Scope Revision Narrative

Austin Police Association Office Building Renovation

Addendum No.: 3

Date: 2026-07-22

SHEET TITLE : GROUND FLOOR PLAN AND REFLECTED CEILING PLAN		
REVISIONS :		
#	Description:	Date:
1	Addendum 3	07/17/2026
SUBMITTAL: PERMIT SET		
SCALE : As indicated		
DATE : 03/09/2026		
PROJECT NUMBER : 25003		
DRAWN BY : A.G.		CHECKED BY : S.R.
SHEET NO. :

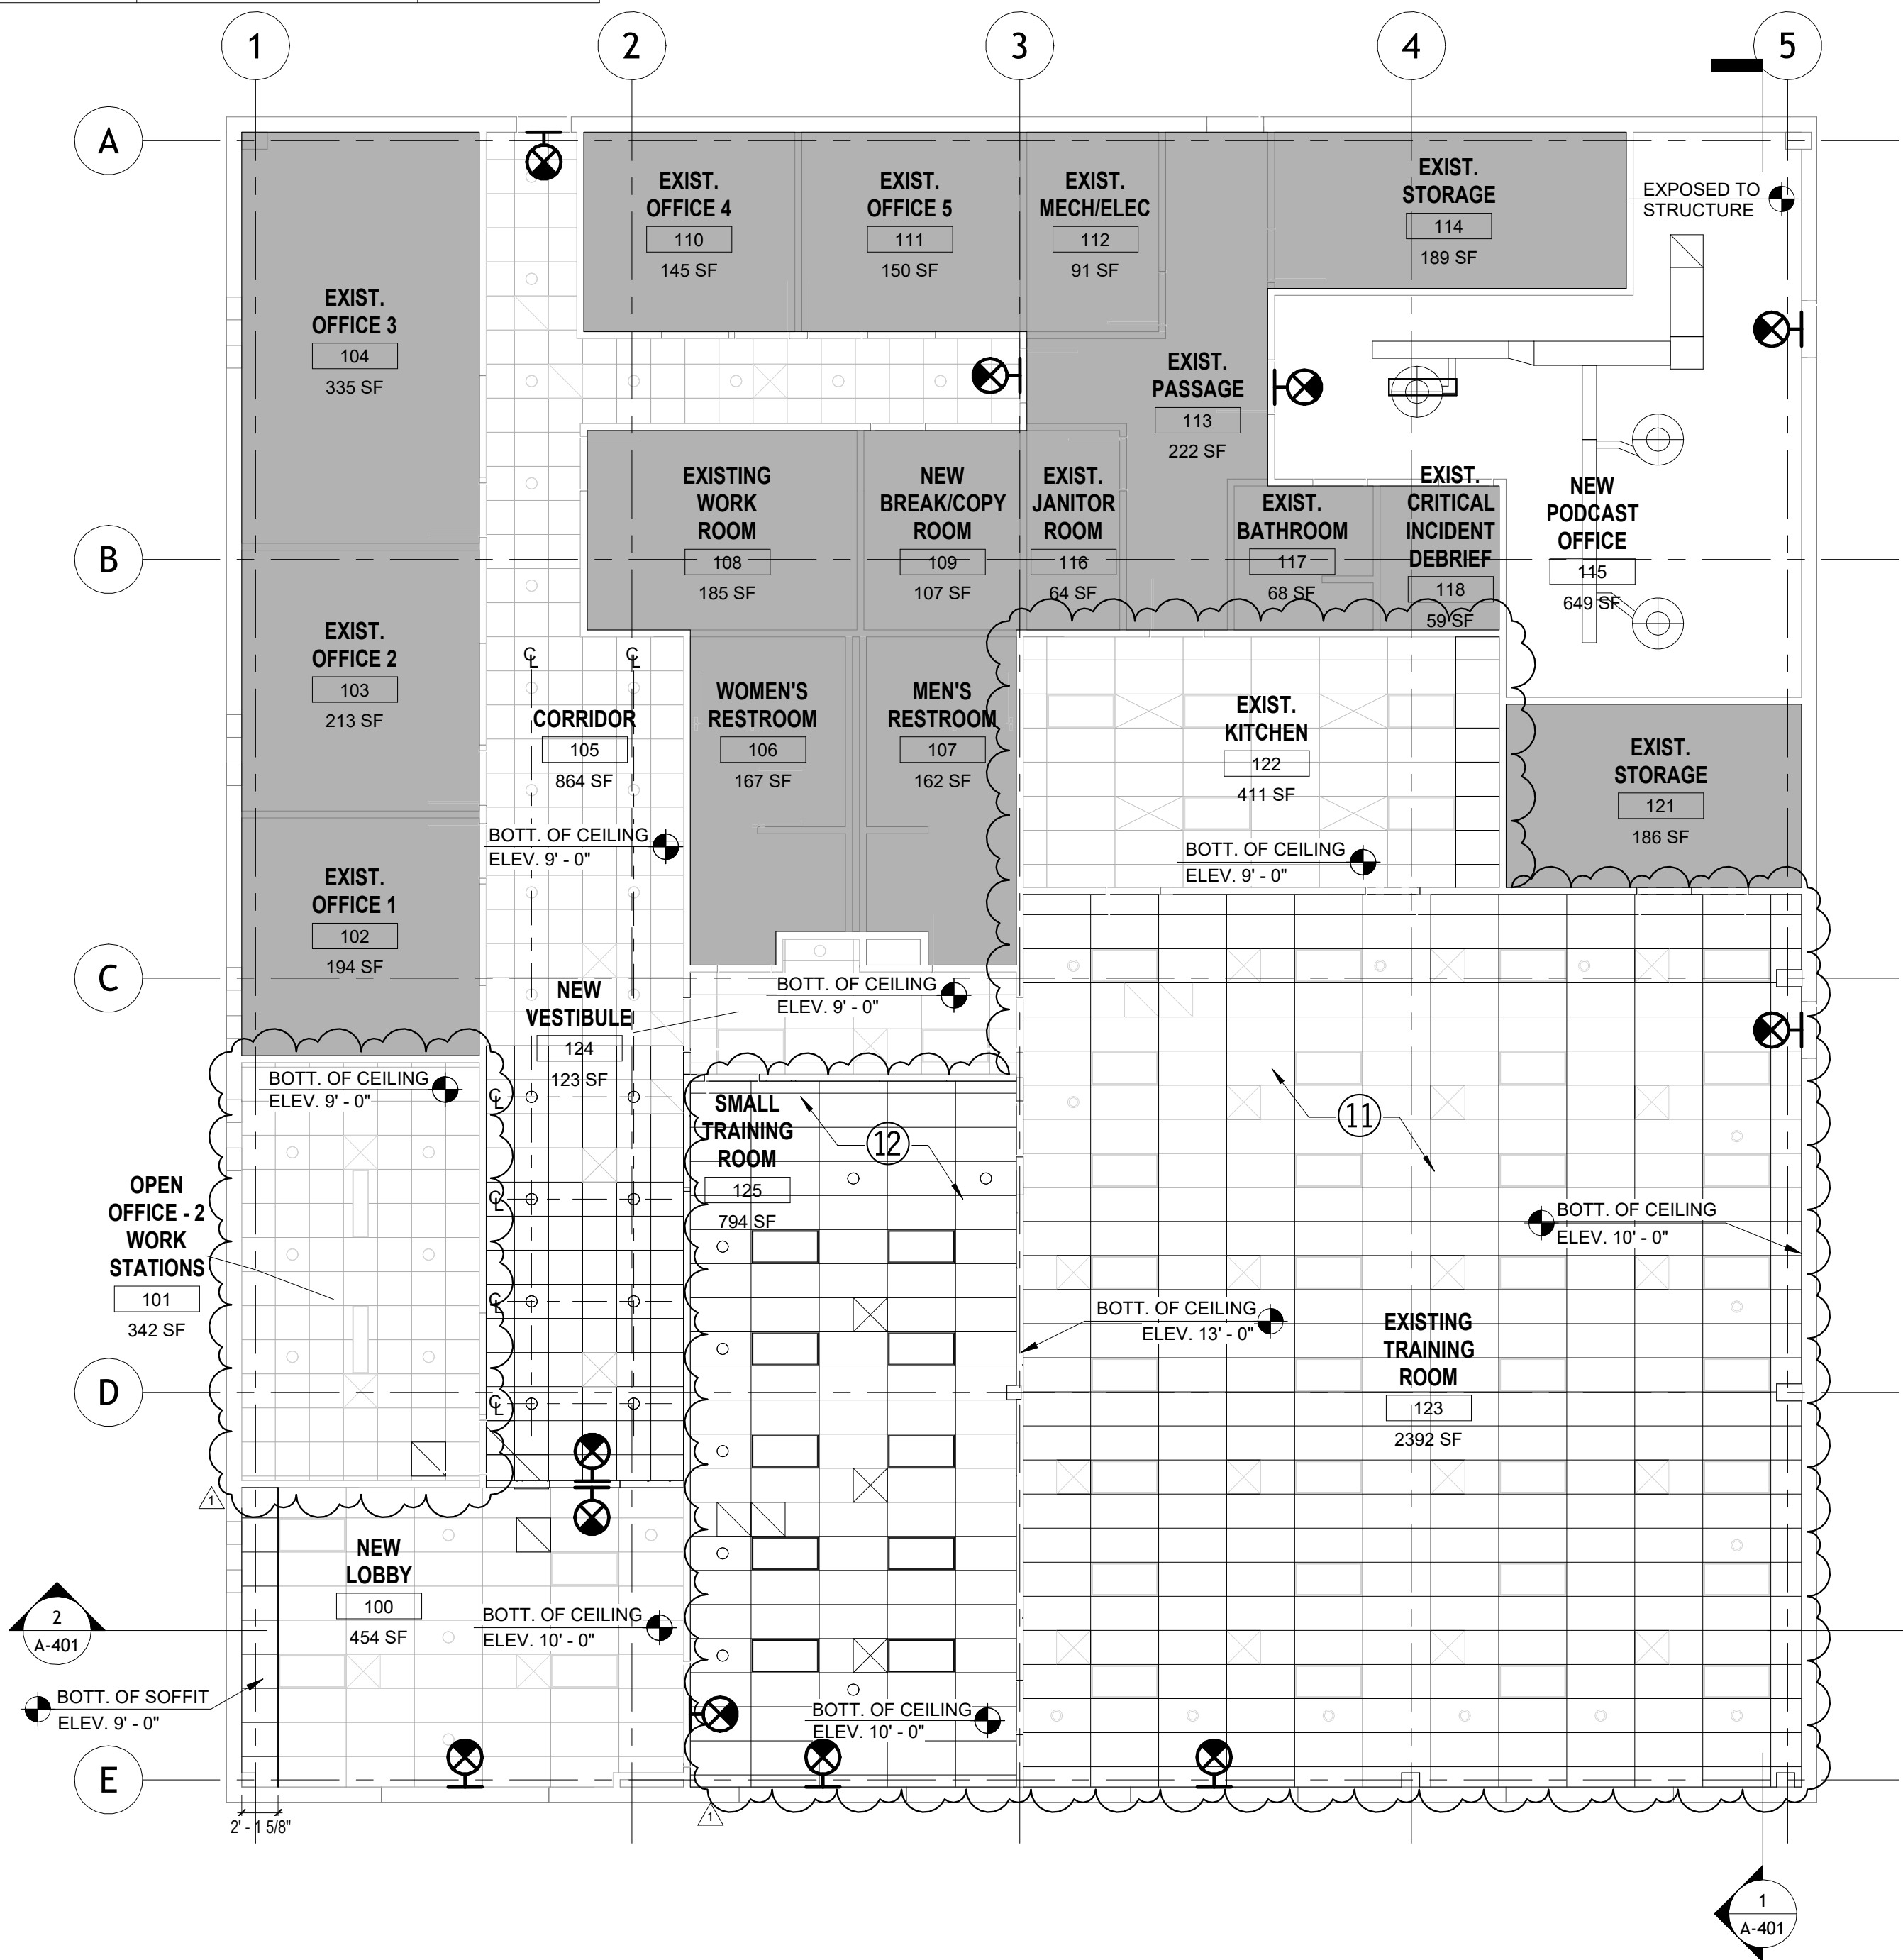
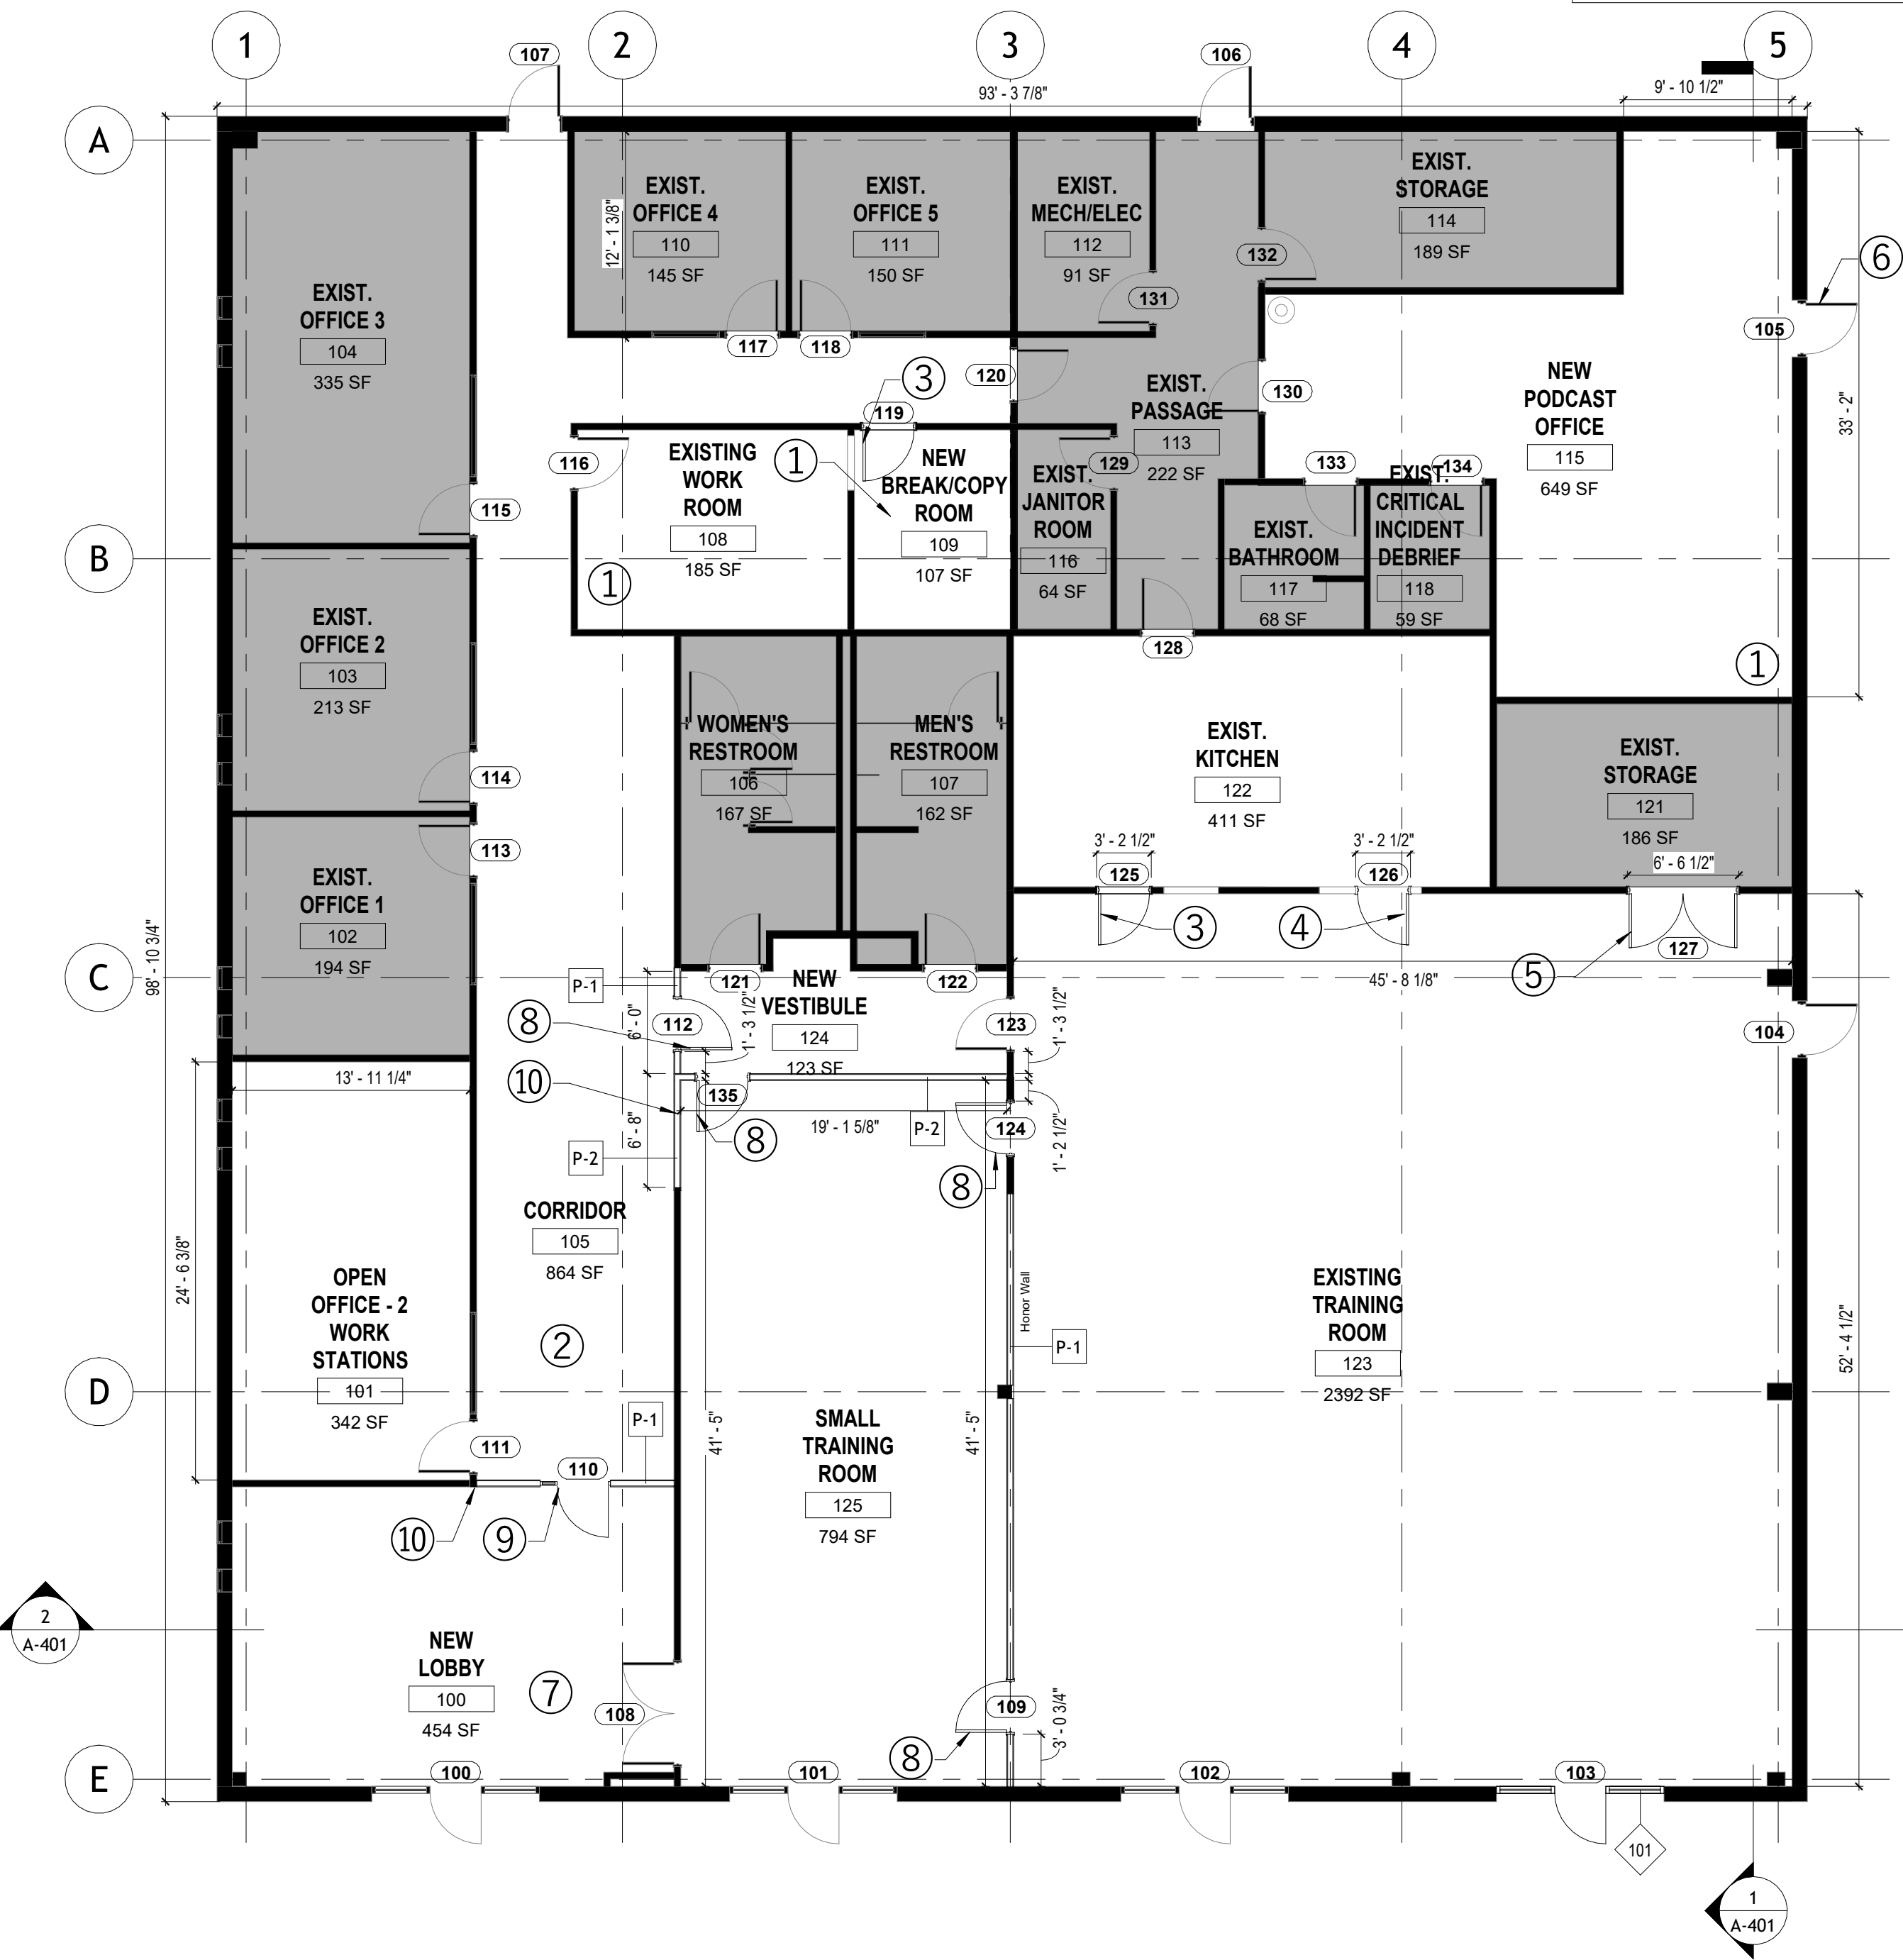
CODED NOTES	
CODED NOTE	NOTE TEXT
①	NEW VINYL TILE. REFER TO ID-210
②	NEW CARPET TILE. REFER TO ID-211
③	SHIFT EXISTING DOOR
④	REPLACE WINDOW WITH DOOR
⑤	NEW DOUBLE DOOR
⑥	RE-SEAL EXTERIOR DOOR
⑦	REPAIR AND REPLACE DAMAGED TILES
⑧	NEW DOOR
⑨	NEW DOOR AND SIDELIGHT
⑩	NEW PARTITION TO BE IN LINE WITH EXISTING
⑪	NEW CEILING TILES ONLY
⑫	NEW CEILING AND GRID. RE-LOCATE EXISTING LIGHT FIXTURES AND EXISTING CEILING DIFFUSERS, REGISTERS, AND GRILLES

1. Ceiling work within the Training Hall / Training Room 123 shall be limited to replacement of ceiling tiles only.
2. The existing suspended ceiling grid shall remain.
3. Replacement of the complete ceiling grid is not included.
4. Replacement ceiling tiles shall match the existing size, type, finish, and appearance as closely as reasonably available.
